# **North Liberty Planning Commission**

Junge Automotive Site Plan

## **Memo**

To: North Liberty Planning Commission  
From: Dean Wheatley, Planning Director  
Subject: Site Plan Approval Request  
(Lot 1 Liberty's Gate Pt 8 & Lot 28 Liberty's Gate Pt 3)

SITE LANDSCAPE PLAN

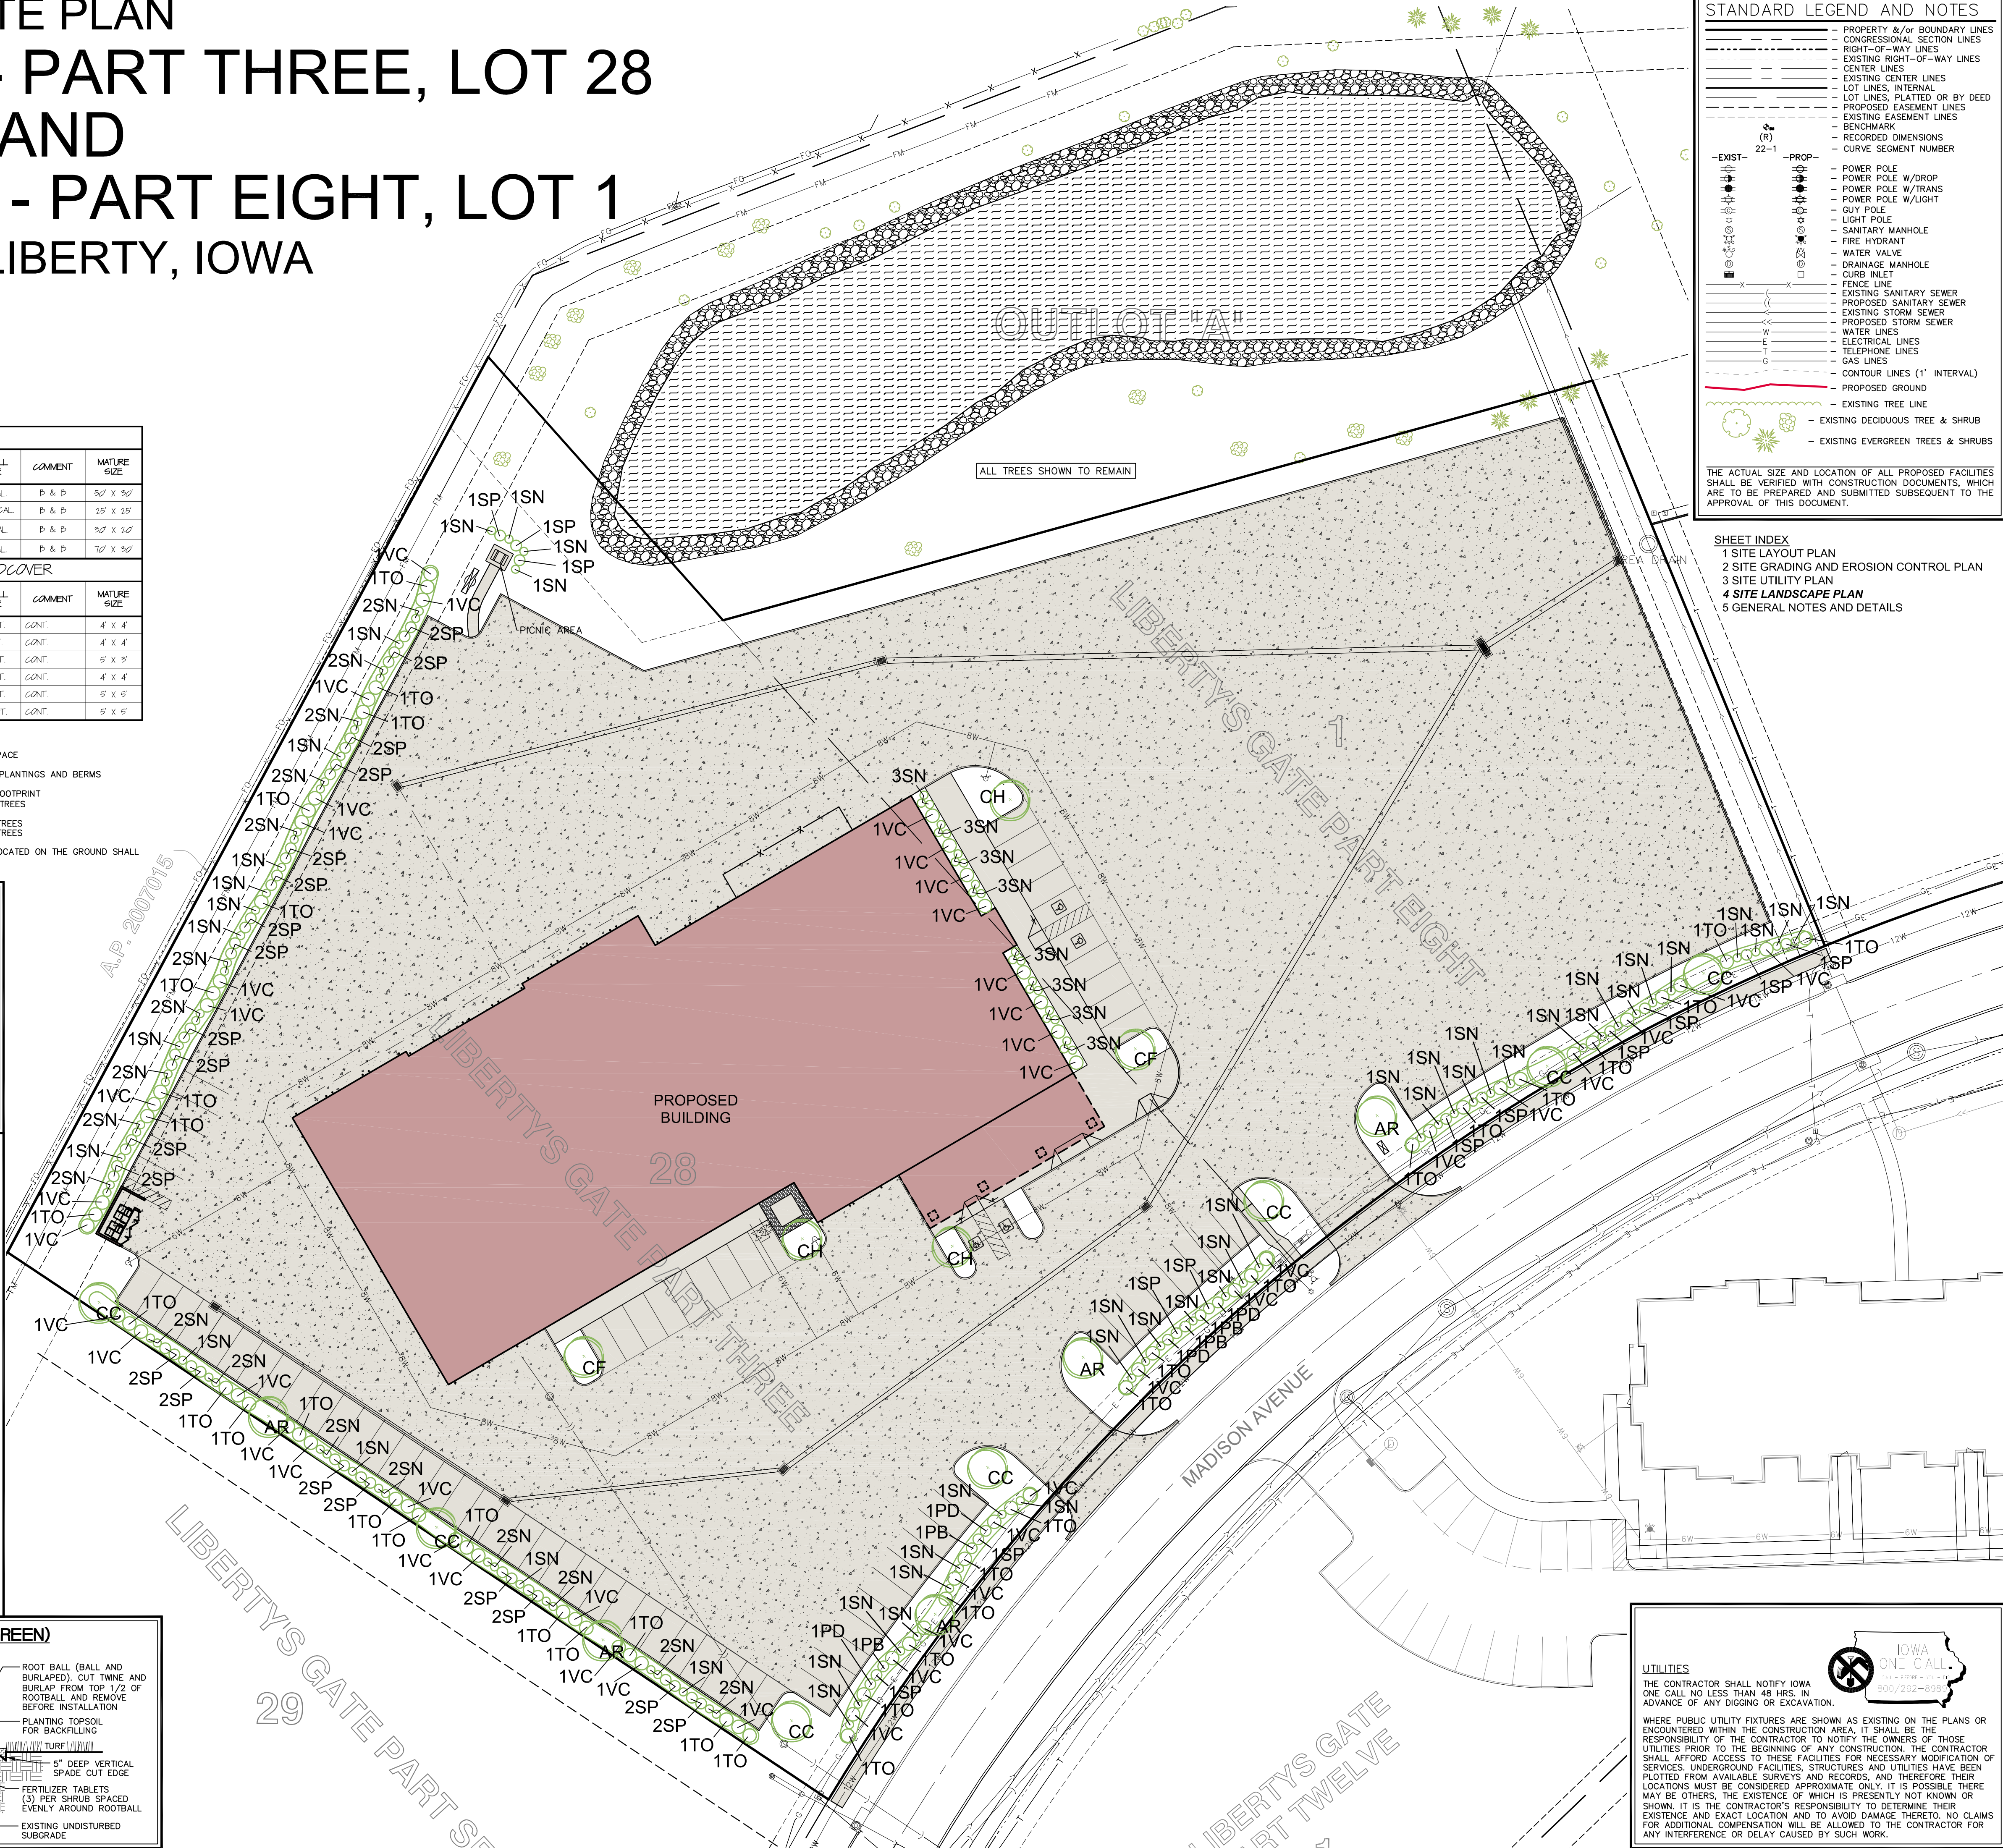
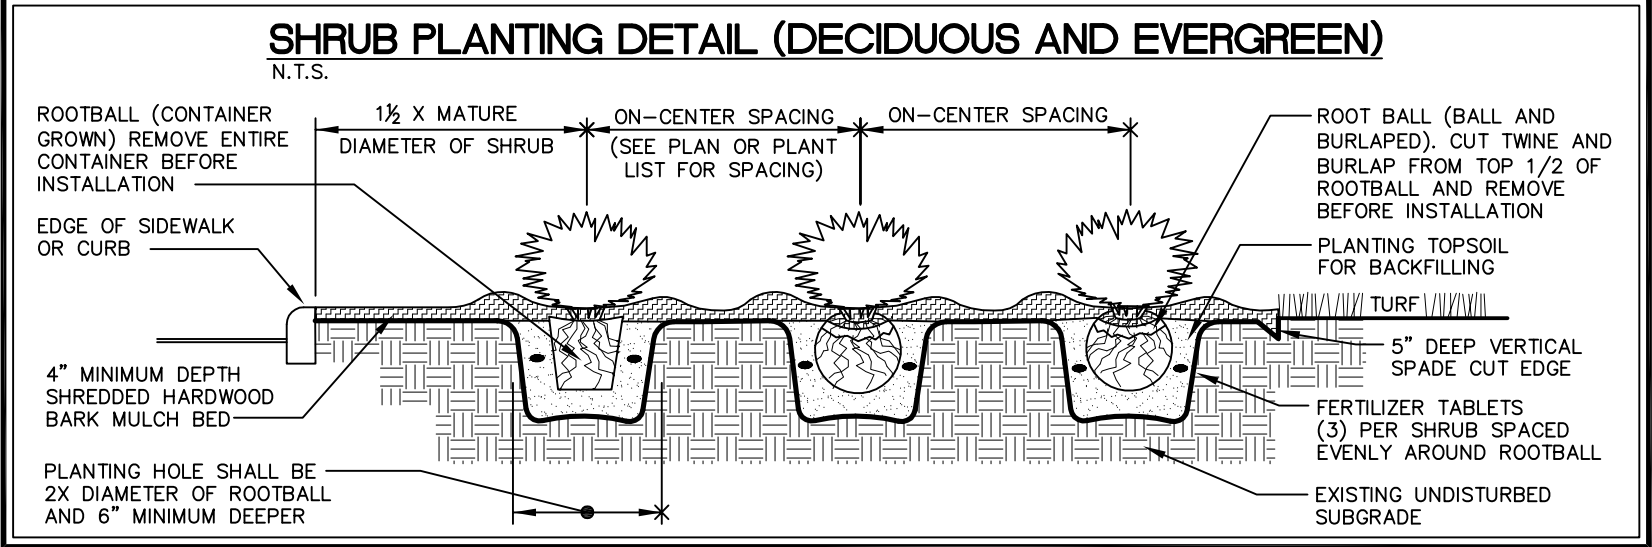
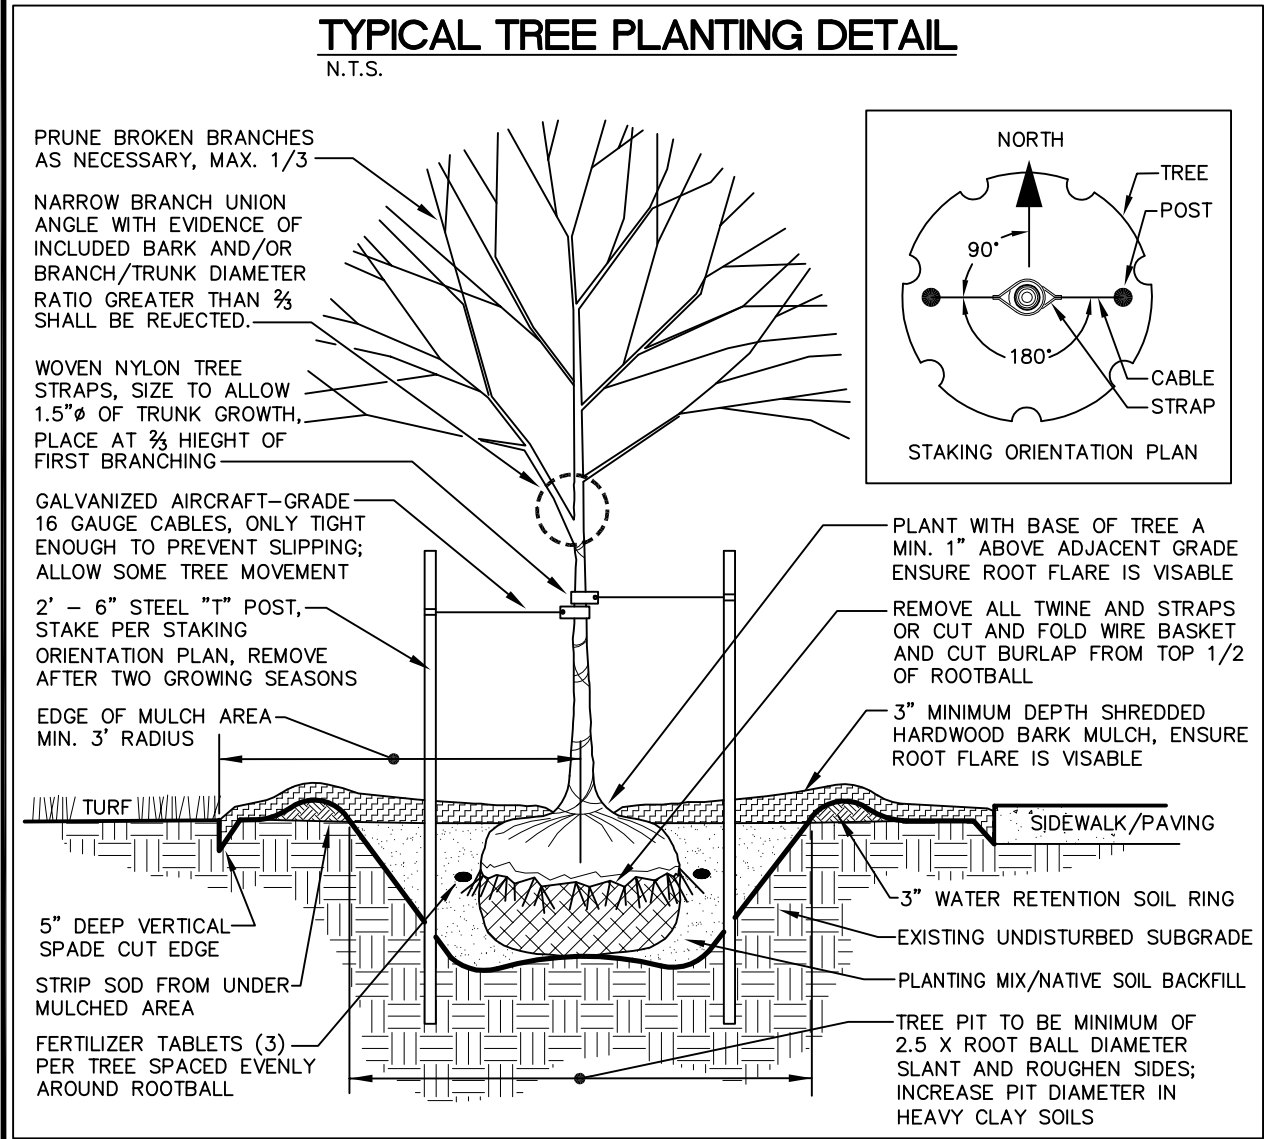
The site layout, typical of car dealerships, is mostly paving to the maximum extent possible with a building in the middle. The site is quite flat and stormwater drainage will be managed through systems developed with the Liberty's Gate subdivisions, so on-site storage is not required. Landscape is minimal but meets requirements for screening of parking and for trees within parking lots, and some non-required plantings are shown along part of the I-380 right-of-way. The Zoning Ordinance does not require trees to be planted within the vehicle display areas. The pedestrian-oriented feature provided as required by the Zoning Ordinance is a small picnic area at the far northeast part of the site for use by employees.

Negotiations with the owner and with his engineering and architectural design team have been cordial and positive, but it seems that we have progressed in those discussion as far as they can go at the staff level, and staff strongly recommends that the Commission and Council insist on a more human scale design approach for the service area portion of the building. In addition, staff recommends some additional or expanded landscaping in the vicinity of the building, and moving the edge of the pavement along Madison back a few feet so that the berms and plant materials there are not directly on top of the private utilities.
